# Wisconsin Department of Transportation

**Proposal #27: 6844-00-70, WISC 2015 190**  
**Waushara County Line -**  
**Waupaca**  
**Lind Center Road Intersection**  
**CTH E**  
**Waupaca County**

**6844-00-71, WISC 2015 191**  
**Waushara County Line - Waupaca**  
**Waushara County Line – High Point Ridge Road**  
**CTH E**  
**Waupaca County**

This is Addendum No. 1, which provides for the following:

**DETAIL FOR EXCAVATION BELOW SUBGRADE (EBS)**  
\*EBS, THICKNESS, LOCATION, & DEPTH VARIES AS DESIGNATED BY THE ENGINEER. QUANTITIES ASSUMED AVERAGE THICKNESS OF 18".

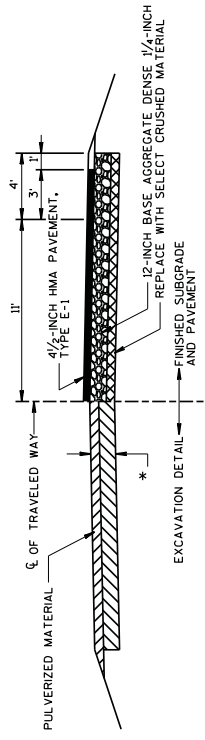
Revised Plan Sheets	
Plan Sheet	Plan Sheet Title (brief description of changes to sheet)
12	Construction Details – Added notes for possible locations of EBS

EBS DEPTH VARIES FROM 0' TO 3' (POTENTIAL LOCATIONS):	
STA 15+00 - STA 20+00	STA 134+00 - STA 140+00
STA 86+00 - STA 92+00	STA 145+00 - STA 165+00
STA 95+00 - STA 98+00	STA 185+00 - STA 192+00
STA 125+00 - STA 125+00
